AEOD TECHNICAL REVIEW REPORT^{1/}

UNIT: Davis-Besse Unit 1 TR REPORT NO.: AEOD/T603
DOCKET NO.: 50-346 DATE: April 30, 1986
LICENSEE: Toledo Edison Co. EVALUATOR/CONTACT: R. Tripathi

SUBJECT: INADVERTENT PUMP SUCTION TRANSFER AND POTENTIAL AUXILIARY
FEEDWATER PUMP CAVITATION AT DAVIS-BESSE

EVENT DATE/LER NO.: January 15, 1985; LER NO. 50-346/85-002-00

Figure-1 Davis-Besse AFW Suction Line-up

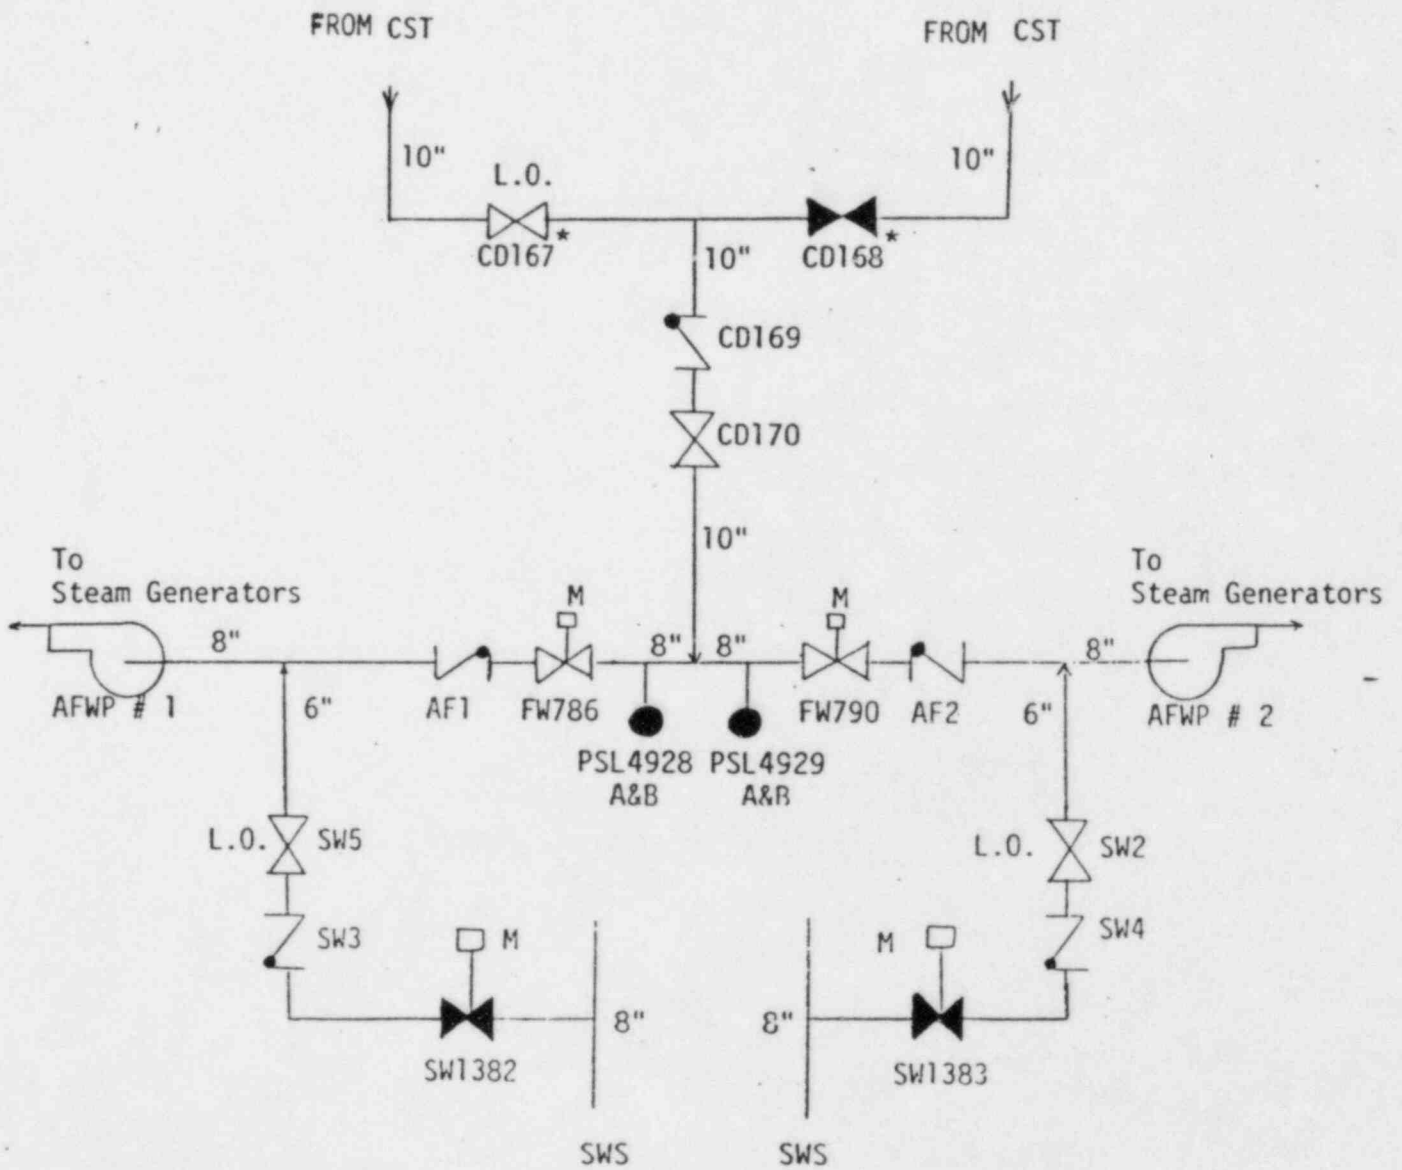
Figure 1 shows a schematic of the supply lines to the AFWPs. In the current design, the feedwater valves FW786 and FW790 close on sensing low suction pressure, and service water valves SW1382 and SW1383 open. If it is an inadvertent transfer to the SWS then the operator would have to manually open the feedwater valves FW786 and FW790, and close the service water valves SW1382 and SW1383. In the proposed modification, the feedwater valves FW786 and FW790 will be left open and de-energized. After receiving a low pump suction pressure signal, the time-delay mechanism in the suction transfer circuitry, after a pre-determined delay (a couple of seconds), will open the service water valves SW1382 and SW1383. In the event of an inadvertent switchover of the pump suction from the CST to the SWS and subsequent isolation of the SWS, the pump will continue to receive suction from the CST. If the CST is available, then in case of an inadvertent pump suction transfer, the operators would only need to isolate the SWS. Thus, with minimal operator intervention, an adequate supply of water to the AFWPs will be ensured.

In the event the CST inventory is depleted, the switchover to the SWS will take place as it does now. The check valves AF1 and AF2, downstream of the feedwater valves FW786 and FW790, respectively, will prevent backflow to the CST as designed. Since the SWS pressure is, typically, 90 psig, the AFWPs will take suction from the SWS rather than draw on the lower pressure segment of the supply line from the CST. The check valves will isolate this portion of the system. We note that both pairs of valves - FW786 & FW790 and SW1382 & SW1383 - receive the low pressure signal at the same time. Furthermore, we have examined the stroke times of the feedwater valves and the service water valves from the last in-service test and note that the service water valves open fully before the feedwater valves close. This proposed modification of leaving the feedwater valves open and de-energized is intended to minimize any potential AFWP cavitation problem. We note that there are two pressure sensors for each AFWP and following single failure of the associated pressure sensor, a potential pump cavitation problem due to the AFWP drawing on empty CST does not exist. In case of a seismic event, leaving the feedwater valves open and de-energized has a disadvantage of draining the service water through a potential break in the piping upstream of the feedwater valves because this portion of the auxiliary feedwater piping is not seismically qualified, thus defeating the design isolation function of the feedwater valves. However, the probability of a seismic event occurring at the Davis-Besse site is small. Therefore, the combined probability of an event similar to the one being discussed occurring concurrent with a seismic event is even smaller.

4. Several design changes are being considered by the licensee. The design modification involving addition of a time-delay mechanism to the AFWP transfer circuit would be effective in preventing an inadvertent transfer of the AFWP suction to the SWS on a momentary low suction pressure. However, if there is an inadvertent transfer, the other design modification (leaving the CST supply breaker open) would ensure an adequate supply of water to the AFWPs in the event the SWS is inadvertently isolated. This would be accomplished with minimal operator action. In case the CST inventory is depleted, no potential problem of AFWP cavitation due to drawing on an empty CST exists. However, the arrangement of leaving the feedwater valves open and de-energized would negate the isolation function of the valves which was one of the design requirements of these valves. Two other proposed changes include lowering of the setpoints of all the four pressure switches and replacement of the existing mesh in strainer S257 by a coarser one.

4. In case the CST inventory is depleted, the proposed modification of leaving the CST supply valve breaker open and deenergized does not present a potential problem of the AFWP cavitation due to drawing on an empty CST. However, in case of a seismic event, this design change has a drawback of draining the service water through a potential break in the non-seismic piping upstream of the feedwater valves. Since the probability of a seismic event at the Davis-Besse site is small, the consequences of this design change are minimal.

- o To ensure an adequate water supply to the AFWP when the SWS is inadvertently isolated, subsequent to a spurious transfer from the CST, the licensee is considering a design modification which involves leaving open the breaker for the CST supply valve. This proposed modification is redundant to the time-delay mechanism discussed earlier.
